Title-Sujet Administration Building HVAC Upgrades Design-Build Batoche National Historic Site, SK		
Solicitation No. - No. de l'invitation 5P420-18-0468/A		Date: January 28, 2019
GETS Reference No. - No de reference de SEAG PW-18-00856829		Amendment No. - N° de la modif. 003
Solicitation Closes:		
at - à 02:00 PM	on - le January 31, 2019	Time Zone - Fuseau horaire MST - HNR
F.O.B. - F.A.B. Plant-Usine: <input type="checkbox"/> Destination: <input checked="" type="checkbox"/> Other-Autre: <input type="checkbox"/>		
Address Inquiries to: - Adresser toute demande de renseignements à : Jen Maheu jennifer.maheu@canada.ca		
Telephone No. - No de téléphone (587) 432-8458		Fax No. - No de FAX: (866) 246-6893
Destination of Goods, Services, and Construction: Destinations des biens, services et construction: See Herein - Voir ici

AMENDMENT 03

This amendment is being raised to distribute questions and answers from the optional site visit on January 15, 2019.

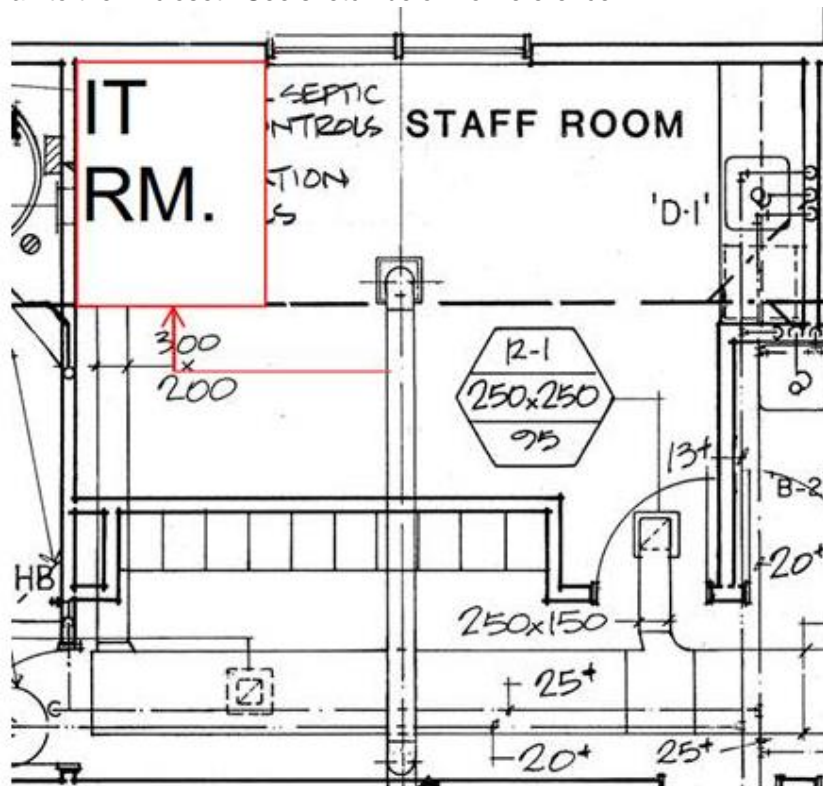
Q3 Is the ventilation in the IT closet included in this contract? If so, what is required?

A3 Yes, the ventilation in the IT closet is included. Extend a duct from the supply duct in the staff room to supply air to the IT closet. See sketch below for reference.
